COVER SHEET
C0.0
1 of 53 Sheets

EAST TOWN CROSSING PHASE 1

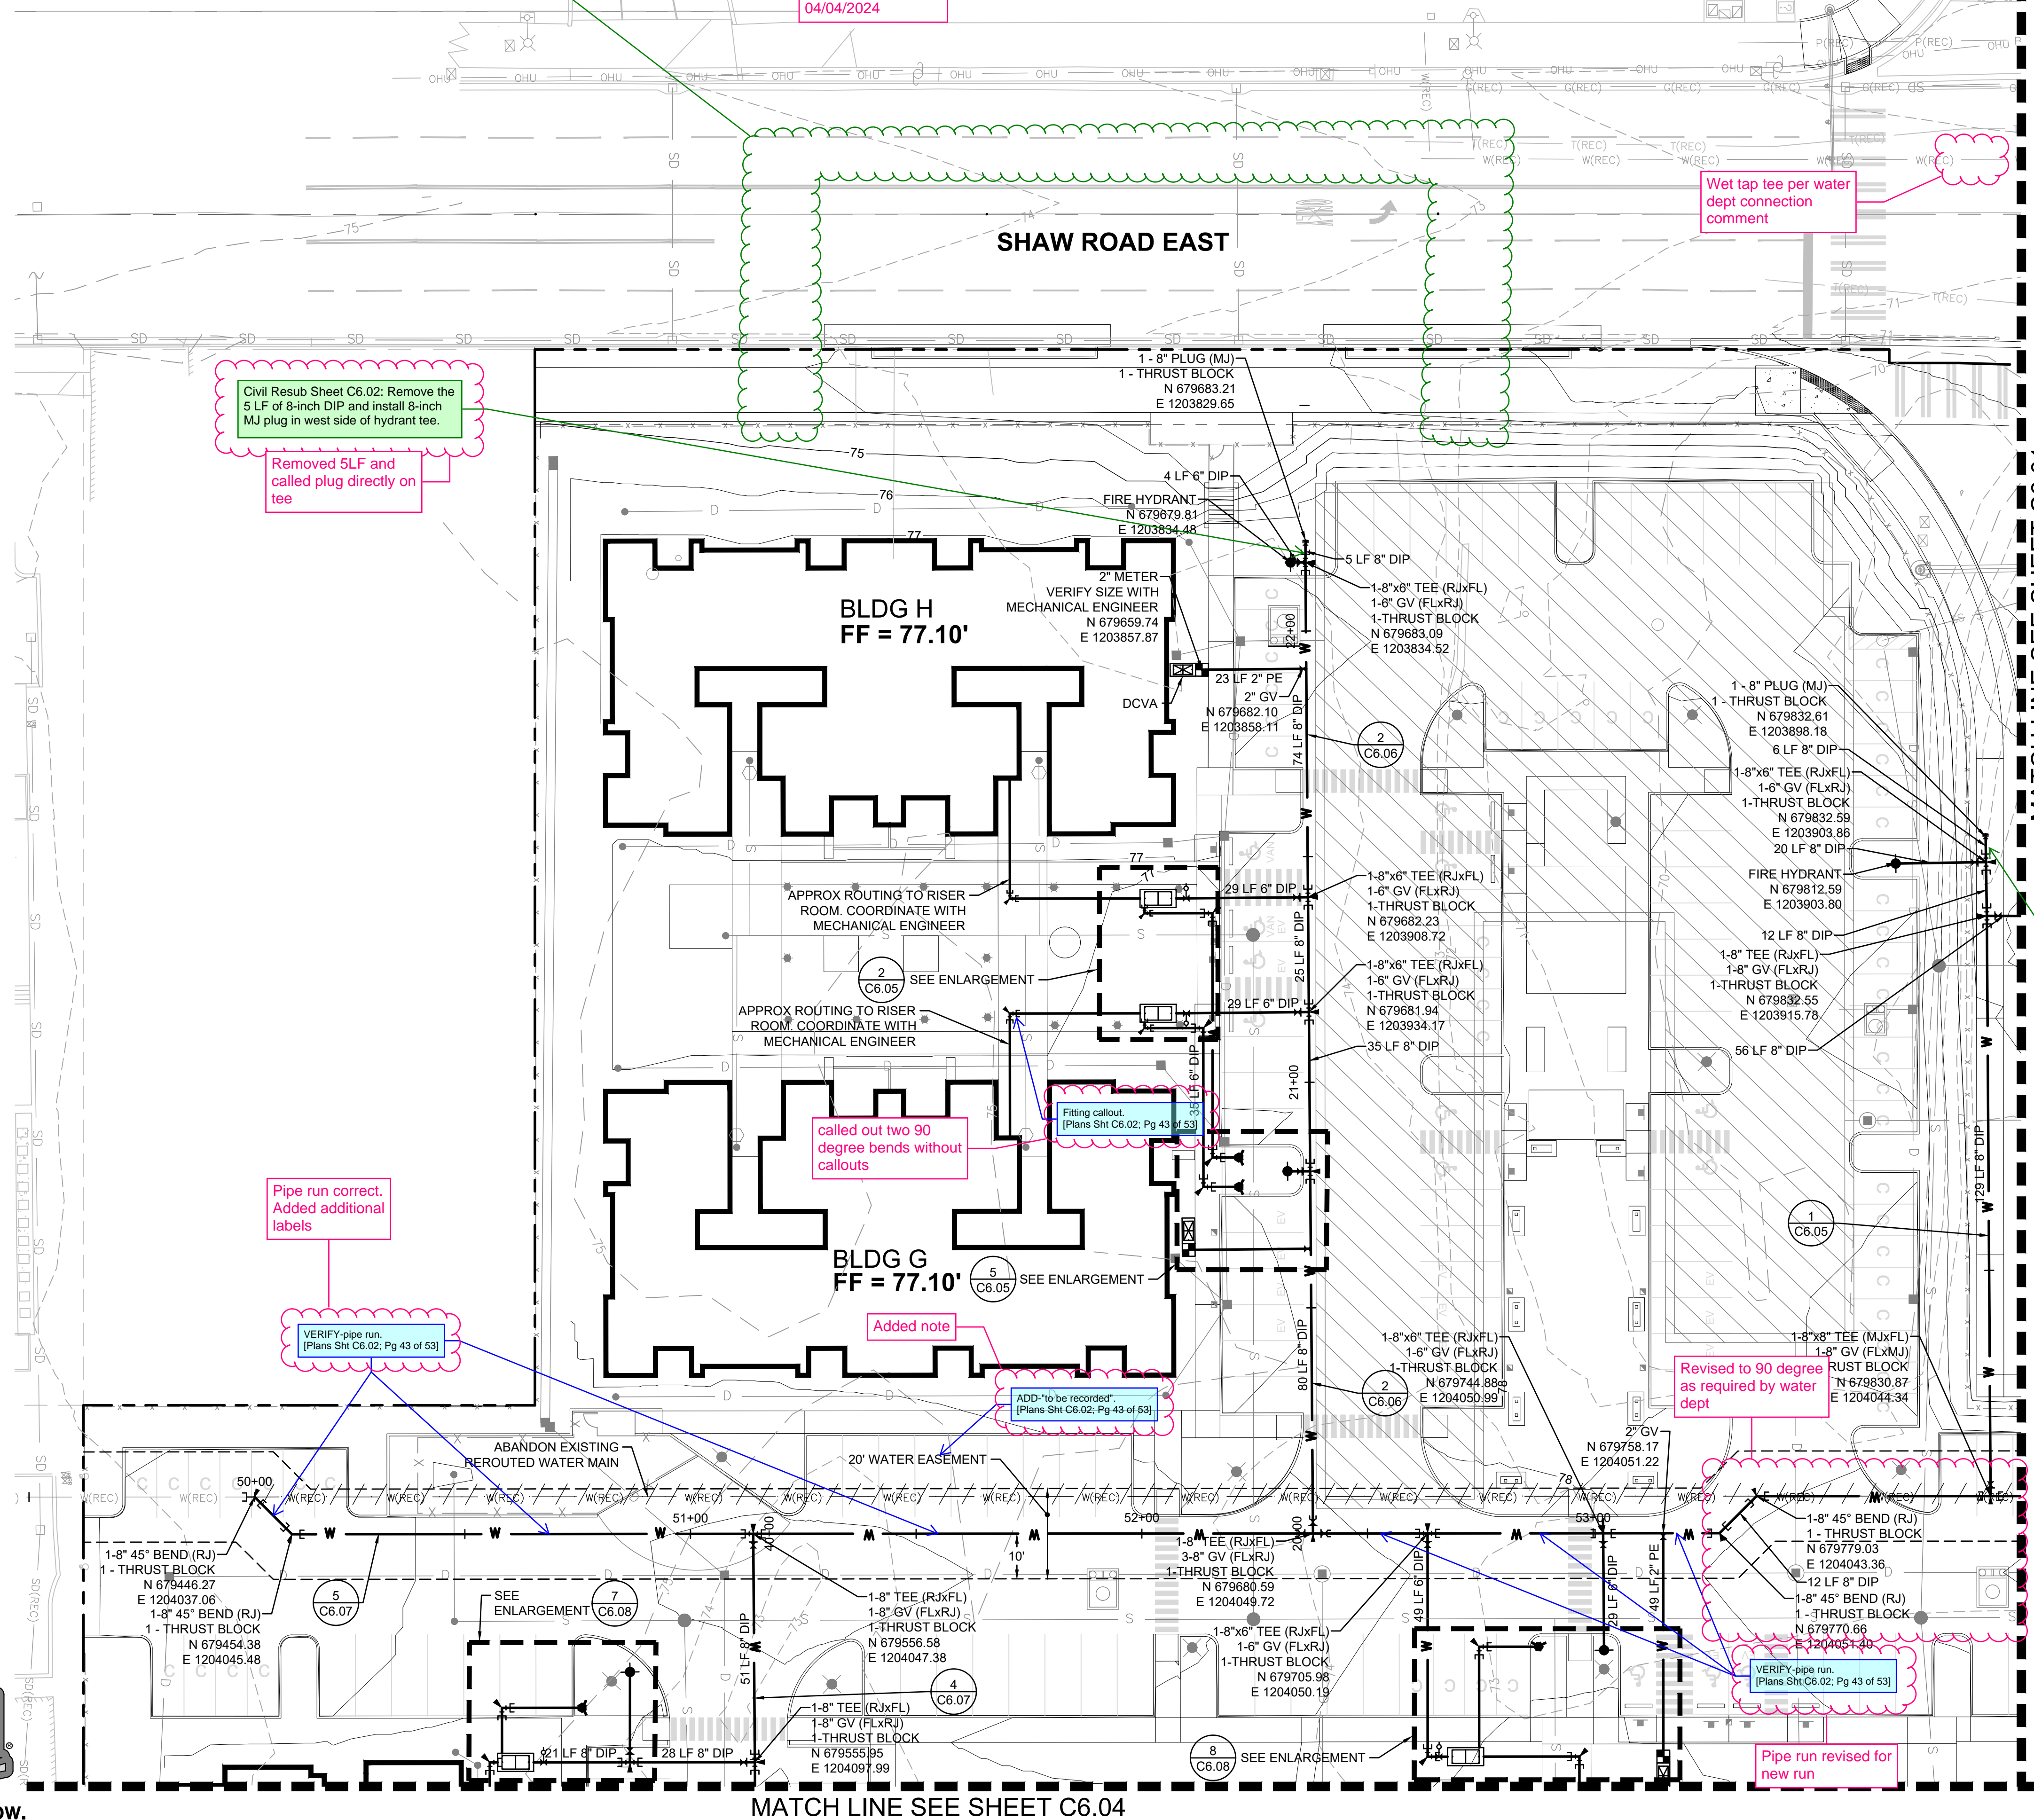
Civil Resub Sheet C6.02: There are two old water services on Shaw Road that need to be removed as part of this project. A water main shutdown will need to be scheduled with the Water Division, and the corporation stops will need to be removed off the water main and replaced with brass plugs.

Civil Resub Sheet C6.02: Remove the 5 LF of 8-inch DIP and install 8-inch MJ plug in west side of hydrant tee.

Fitting callout. [Plans Sht C6.02; Pg 43 of 53]

VERIFY pipe run. [Plans Sht C6.02; Pg 43 of 53]

ADD: to be recorded. [Plans Sht C6.02; Pg 43 of 53]

Civil Resub Sheet C6.02: Remove the 6 LF of 8-inch DIP and install 8-inch MJ plug in west side of hydrant tee.

VERIFY pipe run. [Plans Sht C6.02; Pg 43 of 53]

Revised to 90 degree as required by water dept

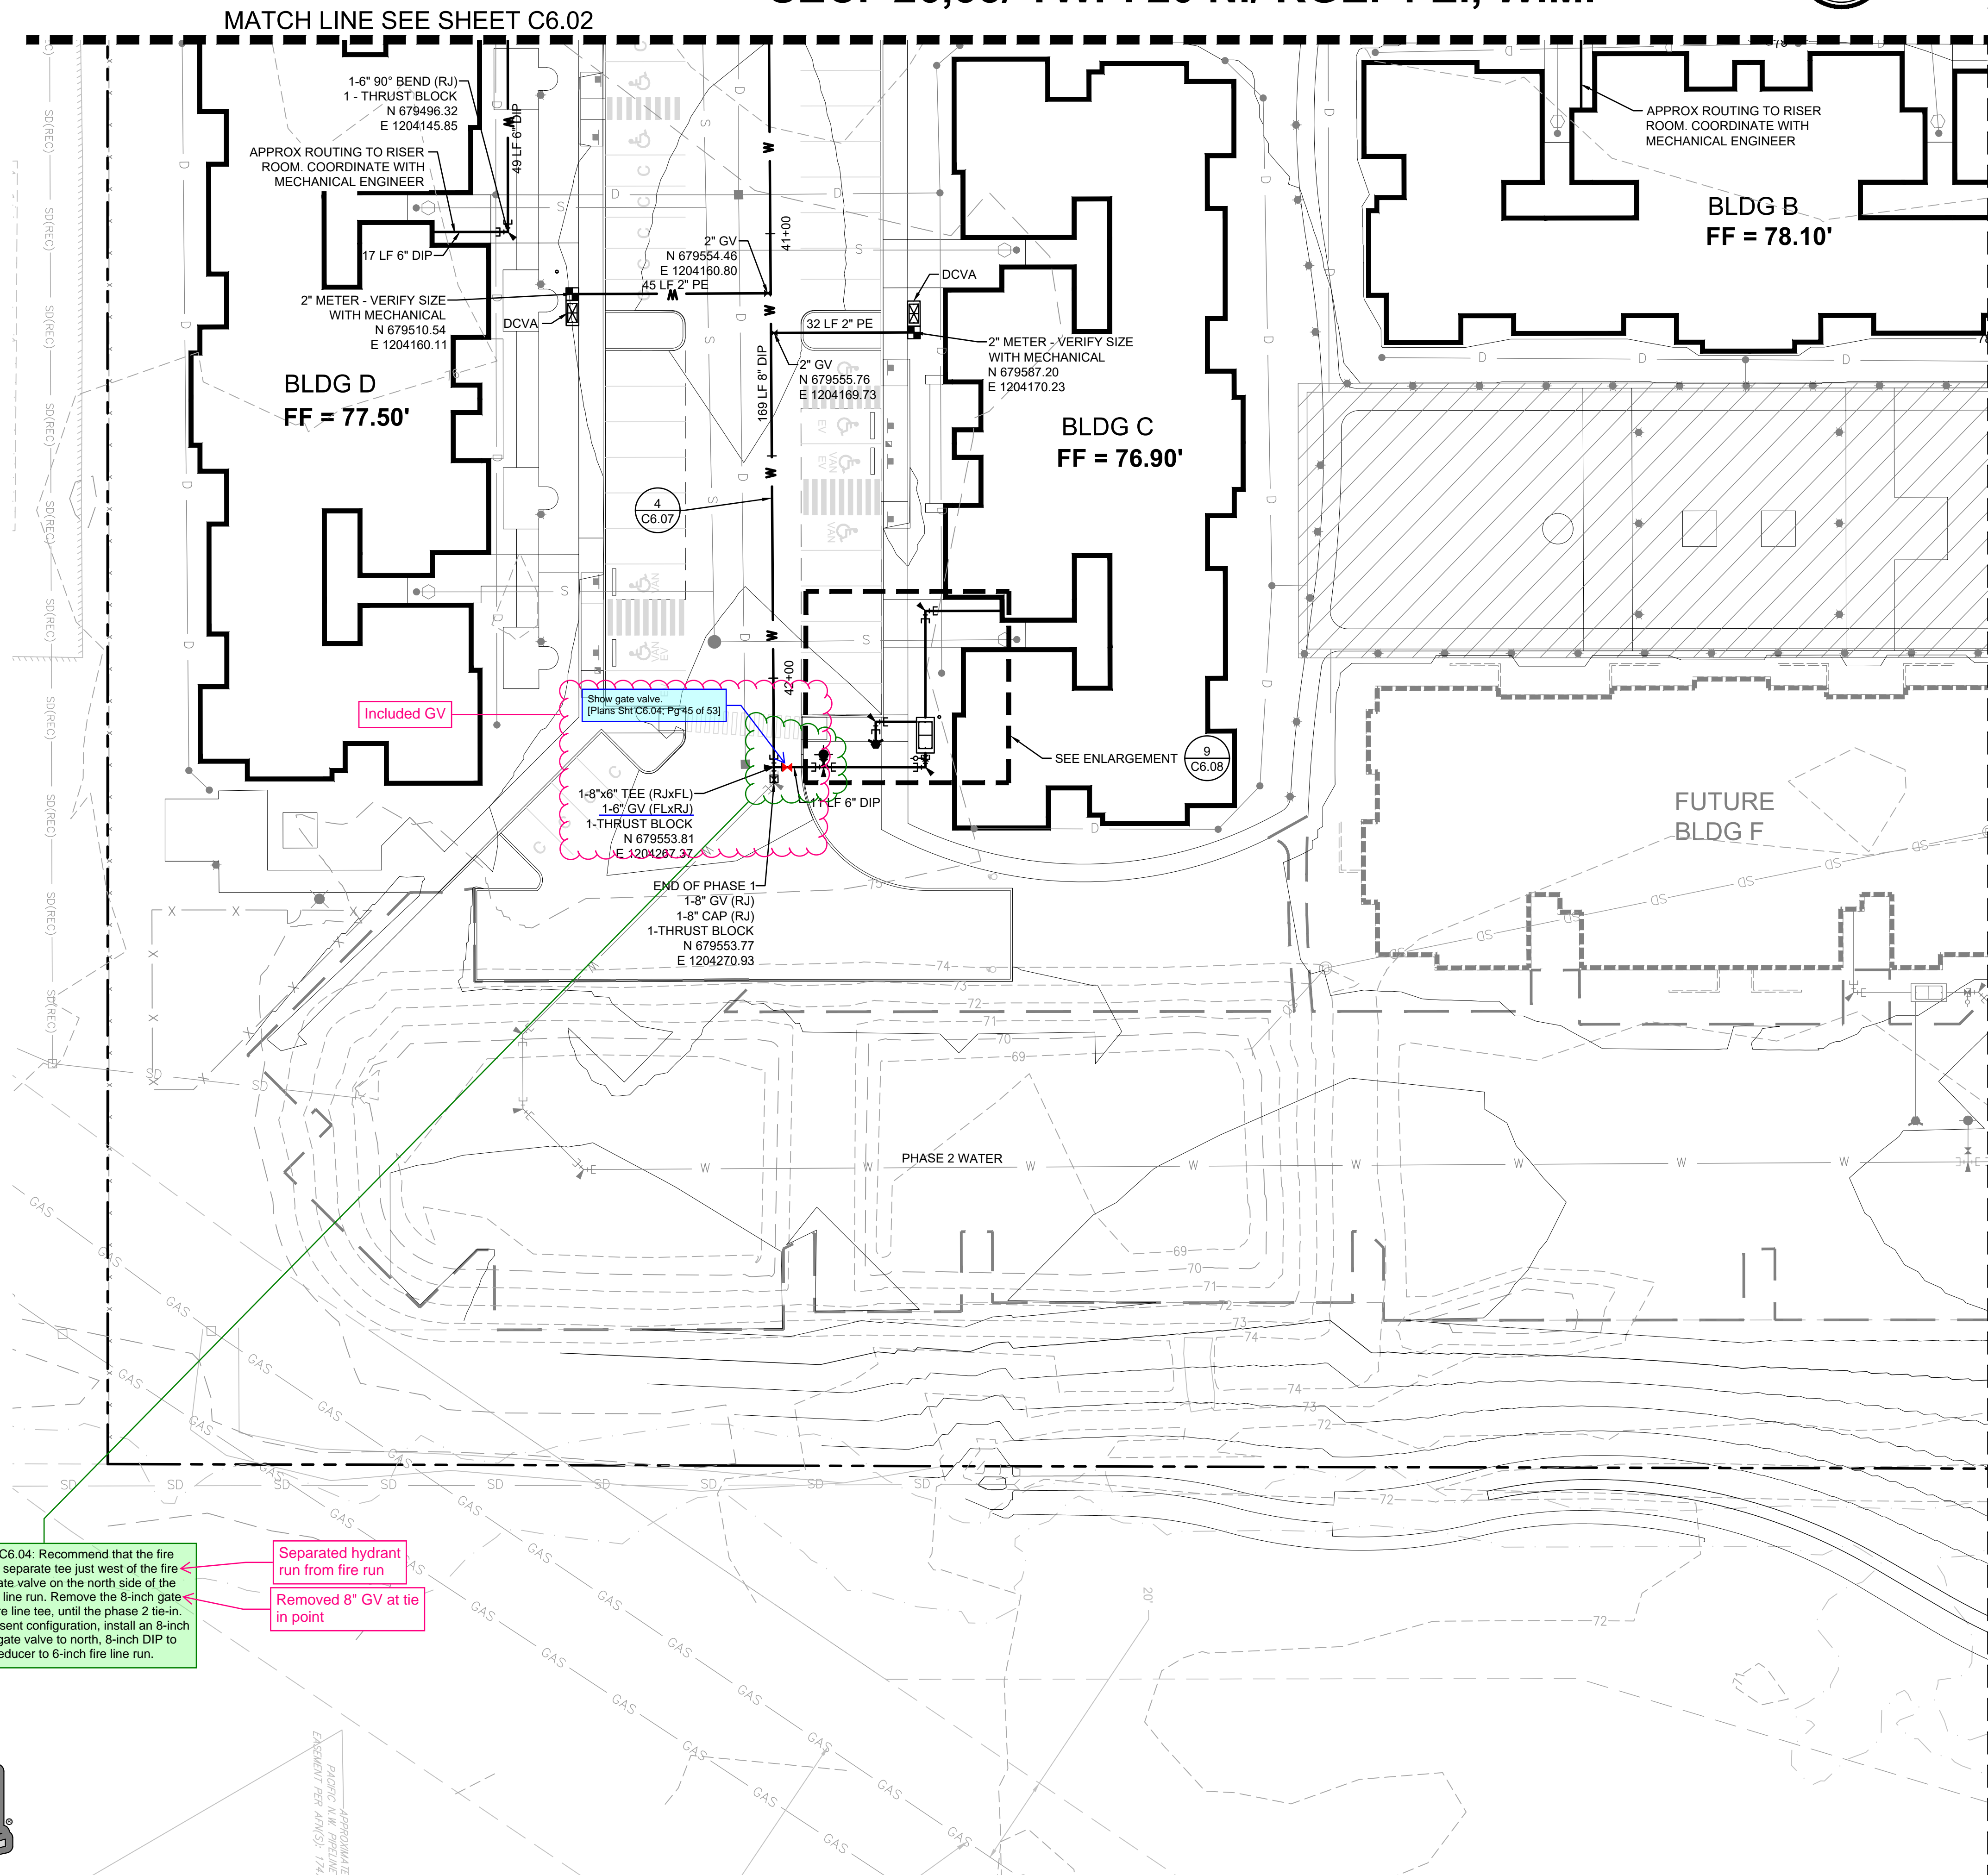
Civil Resub Sheet C6.04: Recommend that the fire hydrant run is off a separate tee just west of the fire line tee. Install a gate valve on the north side of the tee for the solo fire line run. Remove the 8-inch gate valve east of the fire line tee, until the phase 2 tie-in. If you keep the present configuration, install an 8-inch by 8-inch tee with gate valve to north, 8-inch DIP to hydrant tee, then reducer to 6-inch fire line run.

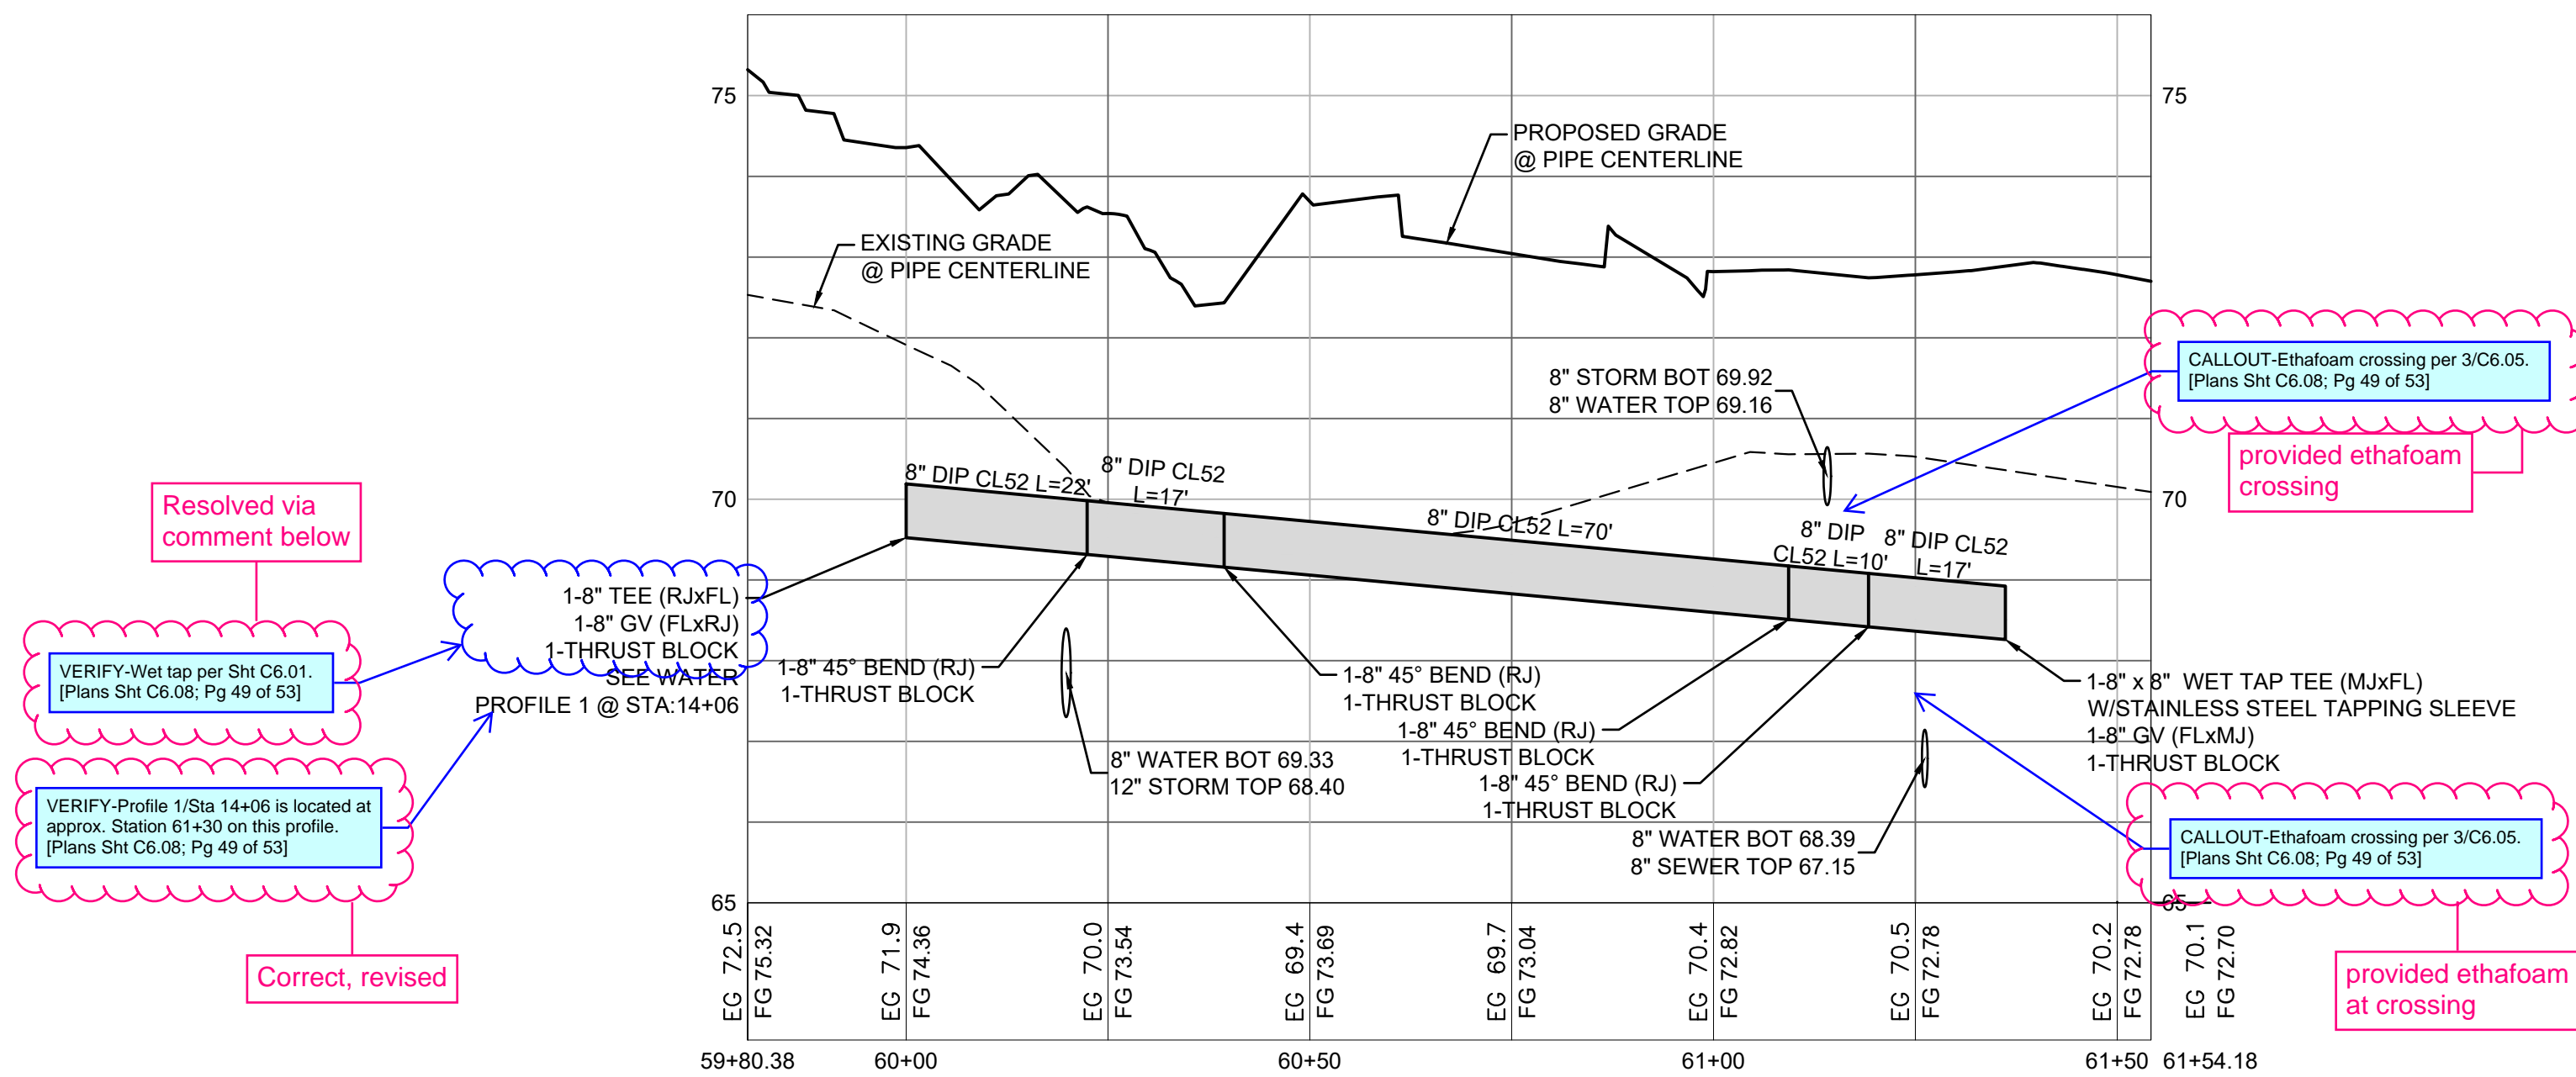
Readability. [Plans Sht C6.08; Pg 49 of 53]
